**PLANNED UNIT DEVELOPMENT  
& SUBDIVISION STAFF REPORT****May 4, 2017**

<b><u>DEVELOPMENT NAME</u></b>	Brewer- Rhodes Subdivision
<b><u>SUBDIVISION NAME</u></b>	Brewer- Rhodes Subdivision
<b><u>LOCATION</u></b>	2695 Government Boulevard Northeast corner of Howell Avenue and Government Boulevard extending to the West side of Merwina Avenue, 91' ± North of Howell Avenue.
<b><u>CITY COUNCIL DISTRICT</u></b>	District 5
<b><u>AREA OF PROPERTY</u></b>	2 Lots / 0.8 ± acres
<b><u>CONTEMPLATED USE</u></b>	Planned Unit Development Approval to amend a previously approved Planned Unit Development to allow shared access and parking between two building sites, and to create two legal lots or record from one existing legal lot.
<b><u>TIME SCHEDULE FOR DEVELOPMENT</u></b>	None given.

# SITE PLAN

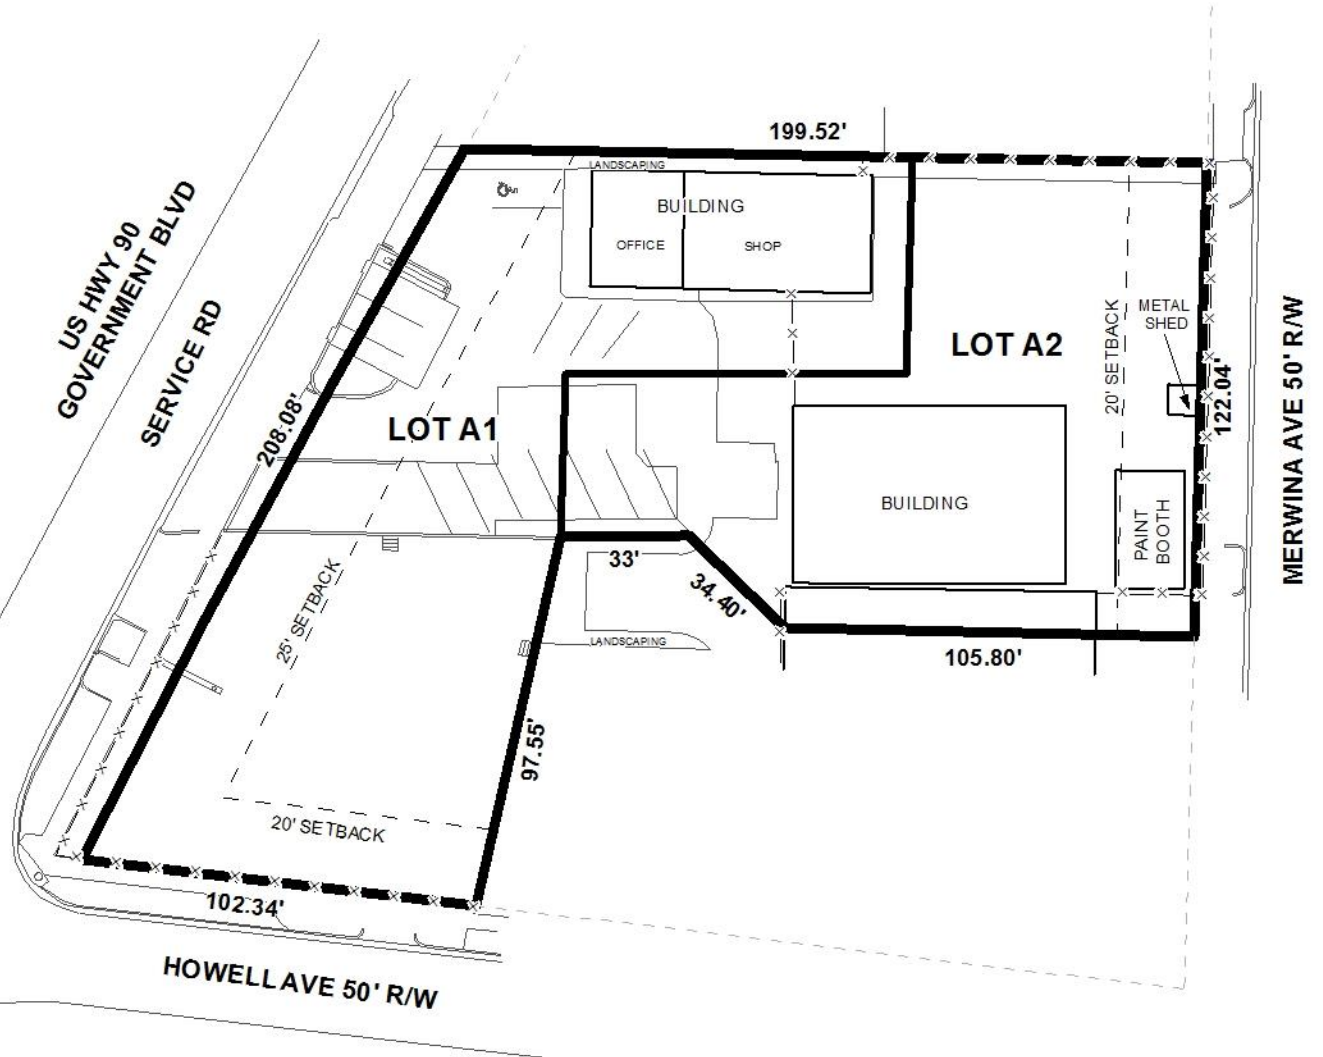
The minimum building setback lines are depicted on the site plan and should be retained on future on any site plans.

A sidewalk is depicted on some areas of the site plan, but is shown as a partial sidewalk that runs onto existing concrete in other areas located on the site. At the time of any new development or redevelopment, a sidewalk along all street frontages of the property will be required or a sidewalk waiver will need to be submitted.

Furthermore, it should be pointed out that the site plan depicts the property to the south, Lot B, as “not included”, however, after reviewing aerial photos the additional property to the south of the subject site will still have cross access, thus the property to the south should be included in the PUD application. The PUD application should be revised to include all properties that partake in cross access and shared access among the sites.

1. revise PUD application to include the property to the south labeled as Lot B; and
2. provision of additional notification labels and fees.
